UNITED STATES PATENT AND TRADEMARK OFFICE

APPLICATION NO.	FILING DATE	FIRST NAMED INVENTOR	ATTORNEY DOCKET NO.	CONFIRMATION NO.
09/418,902	10/15/1999	WALTER V. KLEMP	P01896US0	9464

Office Action Summary

DETAILED ACTION

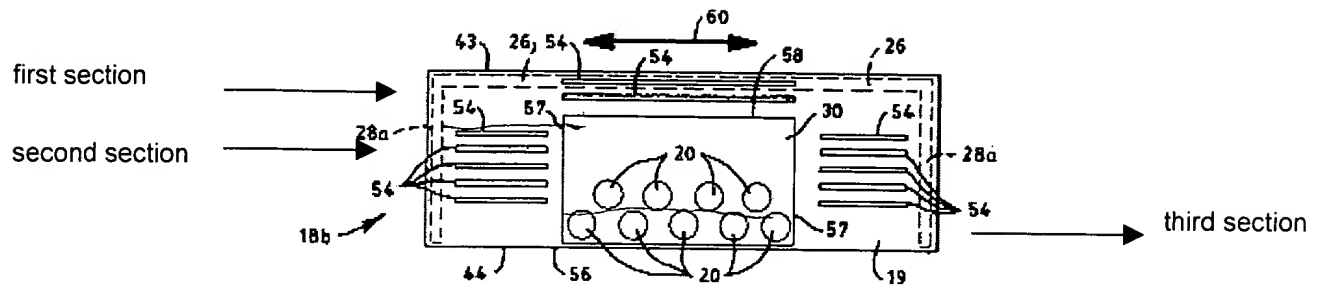
With respect to claim 1, Turner et al (hereinafter referred to as Turner), teaches a disposable absorbent article having side and end edges (10), a topsheet layer (12), a backsheet layer (14), an absorbent core (16), and an end strip (18, 19) as shown below:

Turner discloses the first section having generally elastic properties (col. 9, lines 42 – 43) and laterally extending in generally parallel relation with the end edges (figure 1), and the second section can be understood to be substantially less elastic than the first section since the second section includes apertures (page 11 of the applicant's specification). Likewise, the second section extends in generally parallel relation therewith (figure 1). Additionally, Turner teaches the third section being spaced away from the topsheet and core as set forth in col. 4, lines 65 – 66. Further, Turner discloses each section of the end strip to be distinctly elastic (col. 9, lines 42 – 43) and distinctly positioned relative to said other sections (i.e., the apertured section is different from section with the elastic strands and the surrounding areas).
